Product Change Notice (PCN)

Subject: Bond wire material change for RL78/F13, F14 Series 32pin QFN package products

Publication Date: 3/21/2025

Marking Specification

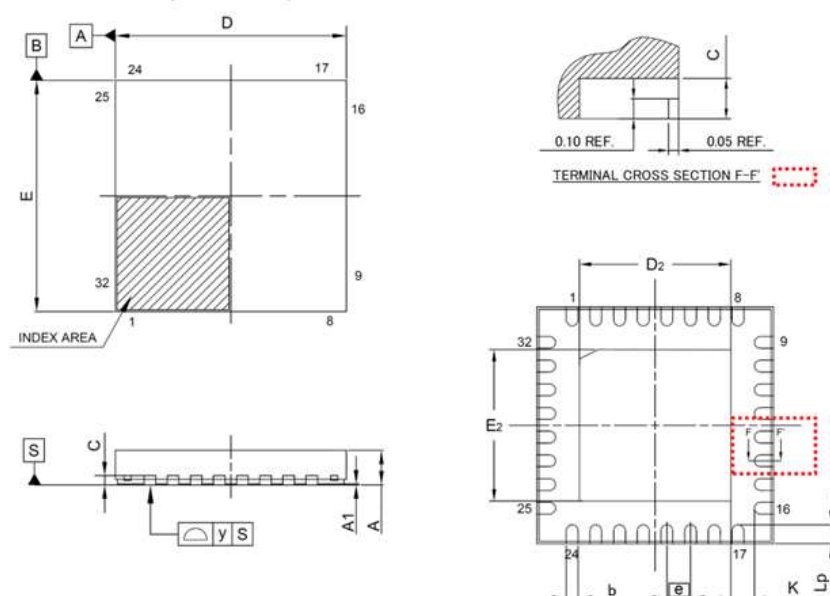
Marking specifications will be changed as follows.

Cu wire Alternate	Au wire Current
RL78/F14 R5F10PBDCKNA#15 製品型名 Product name 内部コード Internal code 1ピン・マーク No.1 pin index mark 製造ロット番号 Assembly lot number 内部コード Internal code	RL78/F14 R5F10PBDKNA#G5 製品型名 Product name 内部コード Internal code 1ピン・マーク No.1 pin index mark 製造ロット番号 Assembly lot number

■Package Outline (2/2)

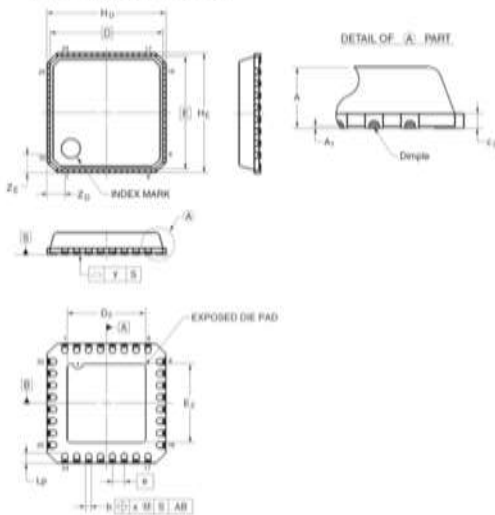
HVQFN with Dimple Wettable flank
Current Au wire

Package Drawing (Dimension comparison)

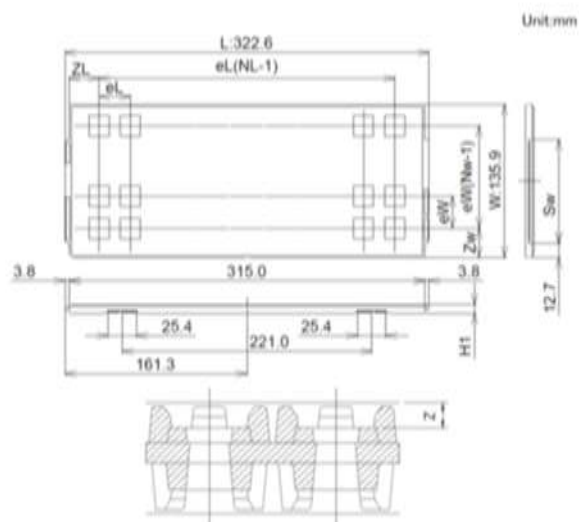
RSKL Symbol New Cu wire	5x5mm 32pin HWQFN PWQN0032KH-A			RSKL Symbol Current Au wire	5x5mm 32pin HWQFN PVQN0032KD-A		
	Dimension in Millimeters				Dimension in Millimeters		
	Min	Nom	Max		Min	Nom	Max
D	4.85	5.00	5.15		-	4.75	-
E	4.85	5.00	5.15		-	4.75	-
A	-	-	0.80	A	-	-	0.90
A1	0.00	-	0.05	A1	0.00	-	-
b	0.18	0.25	0.30	b	0.20	0.25	0.30
	0.50 BSC				-	0.50	-
Lp	0.35	0.40	0.45	Lp	0.30	0.40	0.50
x	-	-	0.80	x	-	-	0.10
y	-	-	0.80	y	-	-	0.05
HD	-	-	-	HD	4.95	5.00	5.05
HE	-	-	-	HE	4.95	5.00	5.05
ZD	-	-	-	ZD	-	0.75	-
ZE	-	-	-	ZE	-	0.75	-
c	-	0.20	-	C2	0.19	0.20	0.21
K	0.20	-	-	K	-	-	-
D2	-	3.20	-	D2	-	3.30	-
E2	-	3.20	-	E2	-	3.30	-

Tray Outline Drawing (Renesas Semiconductor KL Sdn.Bhd.)

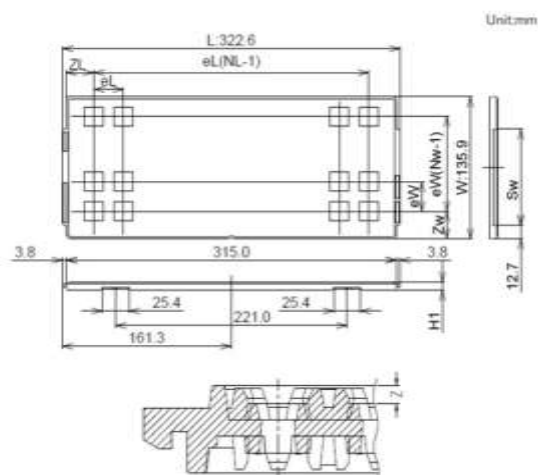
The tray will be changed as follows.

Current Au wire

Tray Code		TX QFN0505 085 1435 6 REVE
Position dimension of cells	Z	1.6
	Zw	8.15
	ZL	7.9
	eW	9.2
	eL	8.8
Thickness (mm)	Sw	92.1
	H1	7.62
	Nw	14
Number of cells	NL	35
Maximum storage No. IC/Tray		490
Maximum storage No. IC/Inner box		3920
Material		Carbon PPE
Heat resistant temperature		135°C MAX
JEDEC or Custom		JEDEC
Surface resistance		Less than $1 \times 10^{11} \Omega/\square$
